ENVIRONMENTAL REVIEW TEAM REPORT

SHELTON LAND FILL
SHELTON, CONNECTICUT

MARCH 1982

The Town of Shelton is presently reviewing a proposed plan for regional use of the Shelton Landfill.

FIGURE 2.
SURFICIAL GEOLOGY MAP

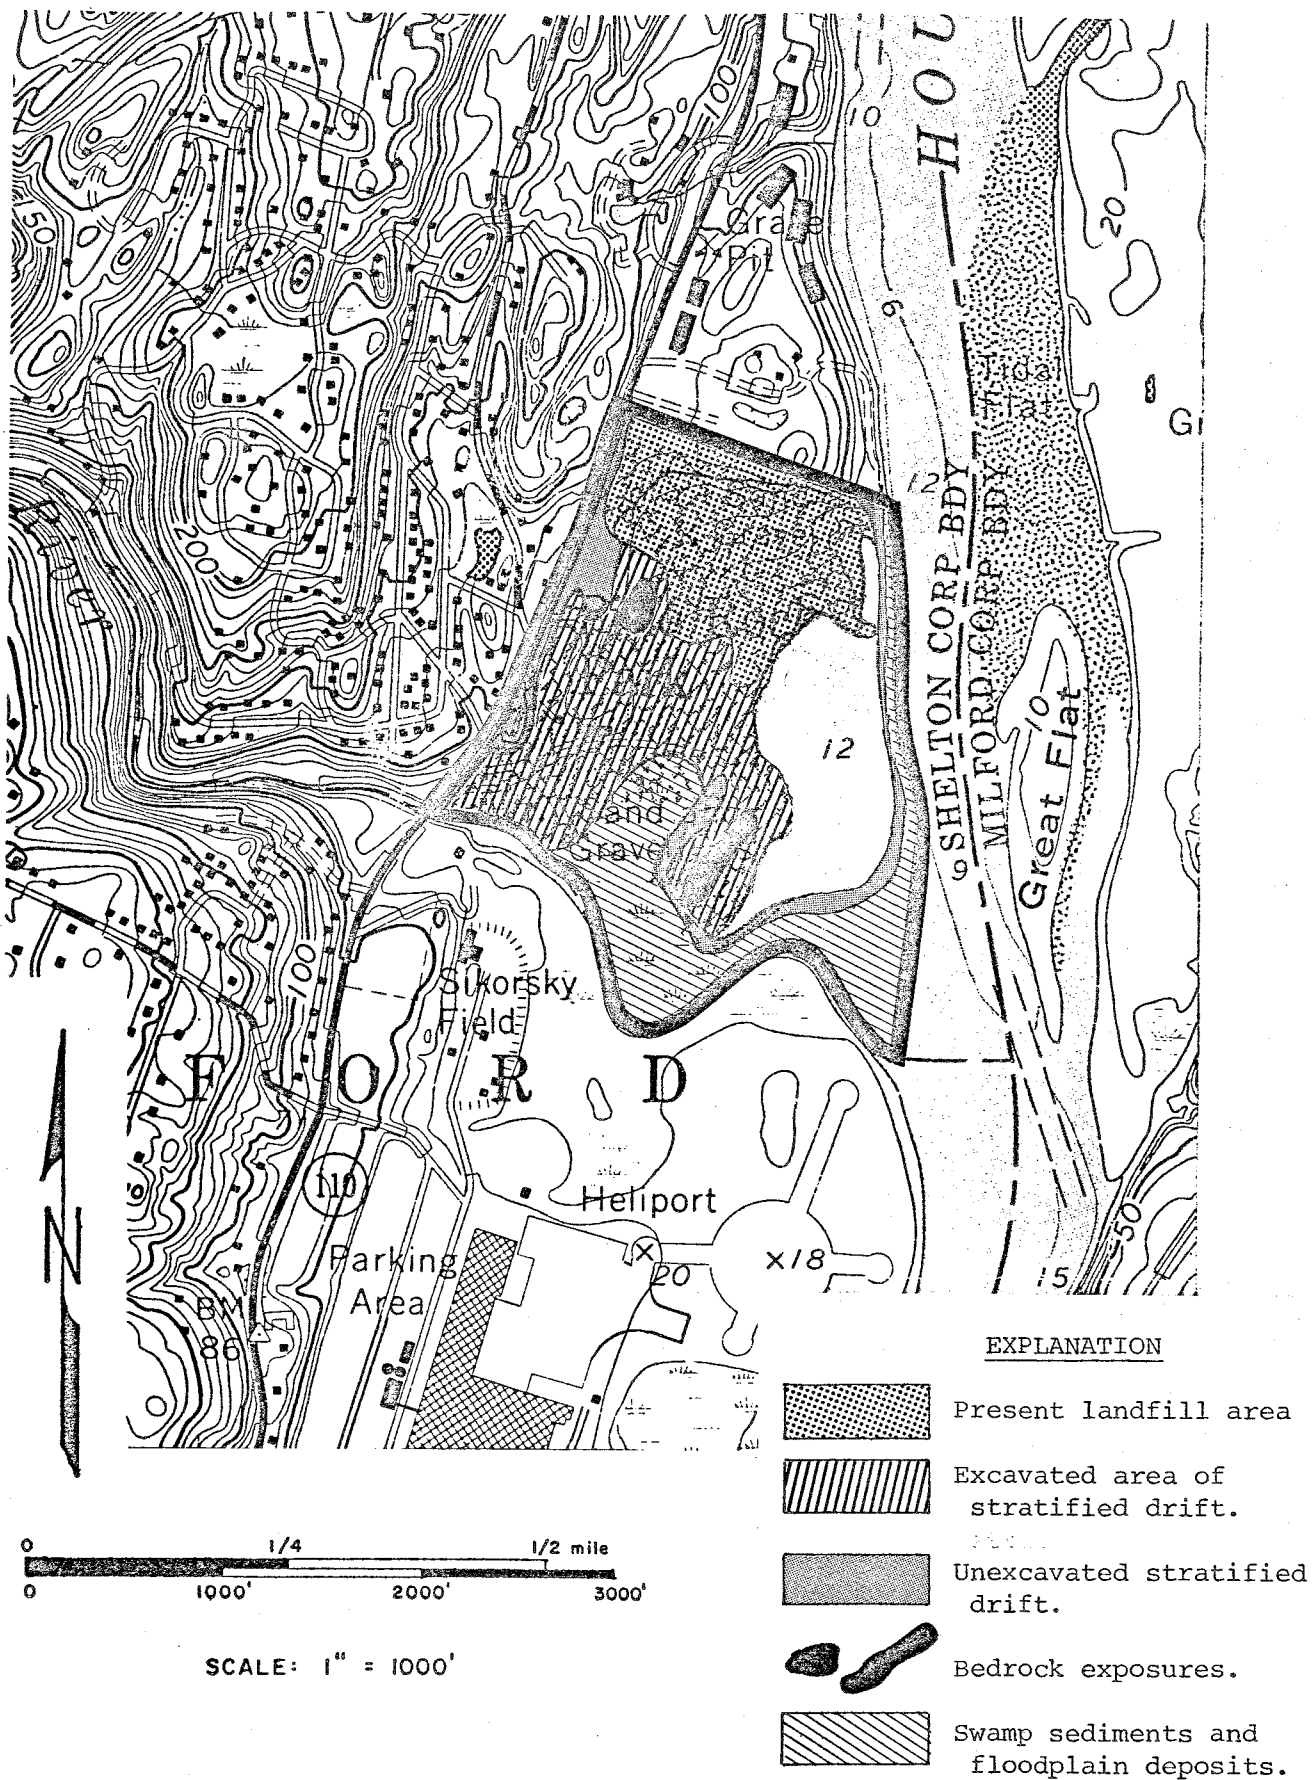
Almost all of the stratified drift within the site has been disturbed (see Figure 2). The upper layers of the northern section have been buried by waste materials, including residential and commercial garbage and rubbish, and some metal hydroxide and asbestos wastes. The southern portion of the site has been largely stripped of its upper layers of stratified drift. A few exposures of crystalline metamorphic bedrock are present on the site.

FIGURE 3

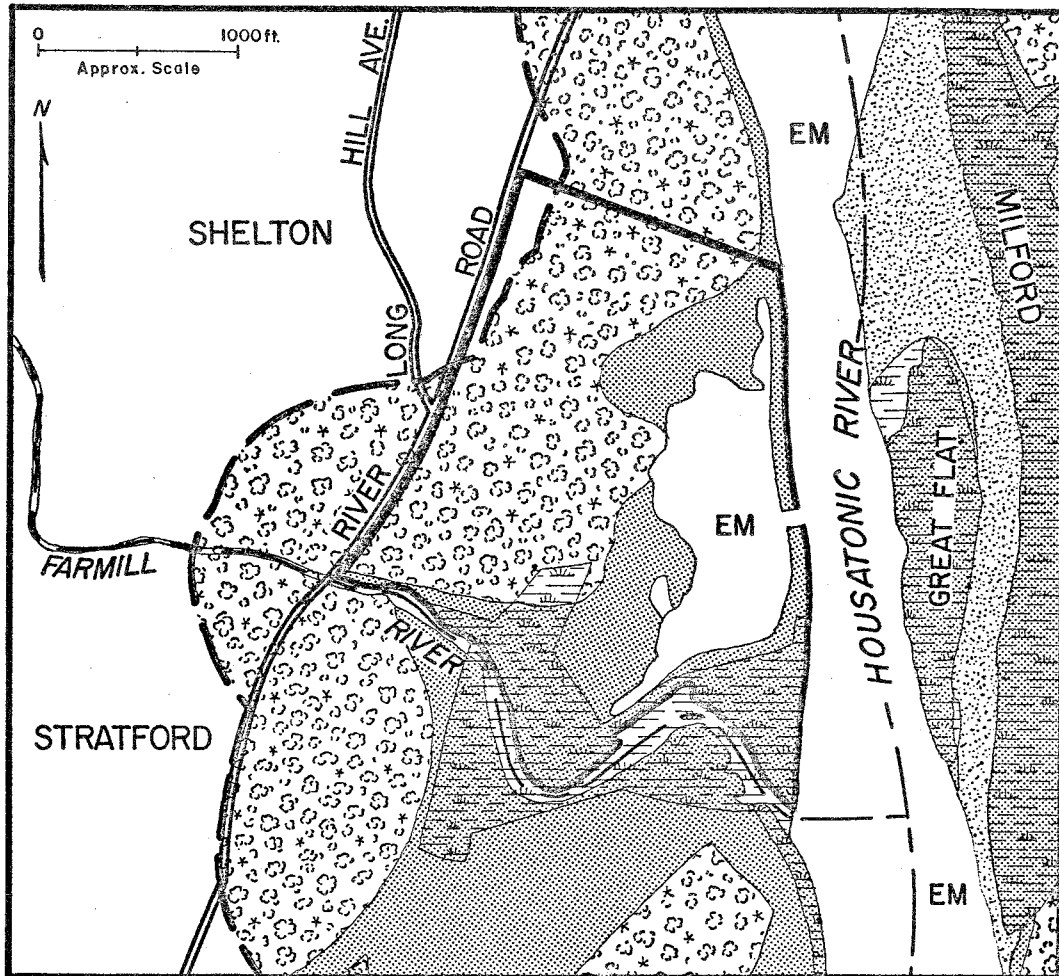
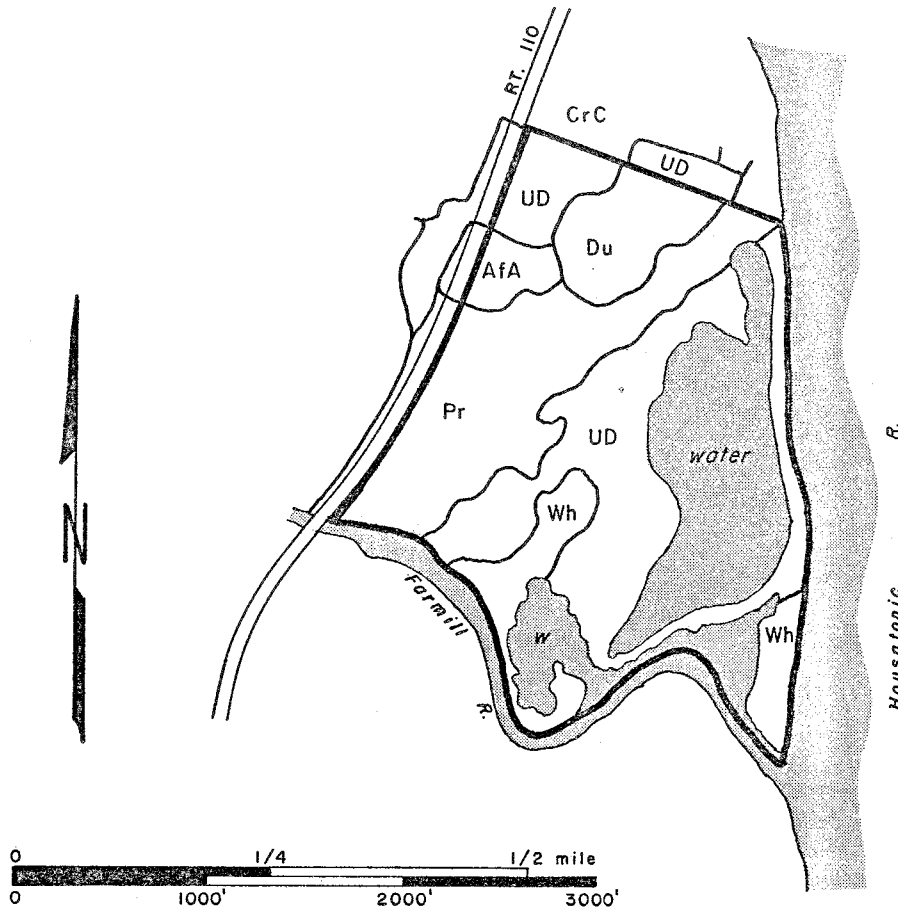
A map illustrating coastal resources on and adjacent to the site should be submitted as part of the state permit and/or municipal CSPR application. On-site coastal resources have been identified as Shorelands, Coastal Hazard Area, Estuarine Embayment (lagoon) and Tidal Wetlands. Adjacent coastal resources have been identified as Estuarine Embayment (Housatonic River) and Intertidal Flats (see Coastal Resources Map).

- Degradation of tidal wetlands by direct encroachment at the southern portion of the site. Any landfill activity within the tidal wetland boundary would constitute an unacceptable adverse impact and render the proposed project inconsistent with the tidal wetlands policies within the CCMA. Further, to adequately protect the tidal wetlands, a substantial setback (100⁺ ft.) should be established.

- Degradation of water quality during and after floods of 100 year significance. Portions of the proposed landfill expansion area fall within the 100 year FEMA flood boundary. It is recommended that the expansion area be sited as to minimize the portion of landfill activity within the flood hazard area, keeping to the shoreland areas wherever possible.
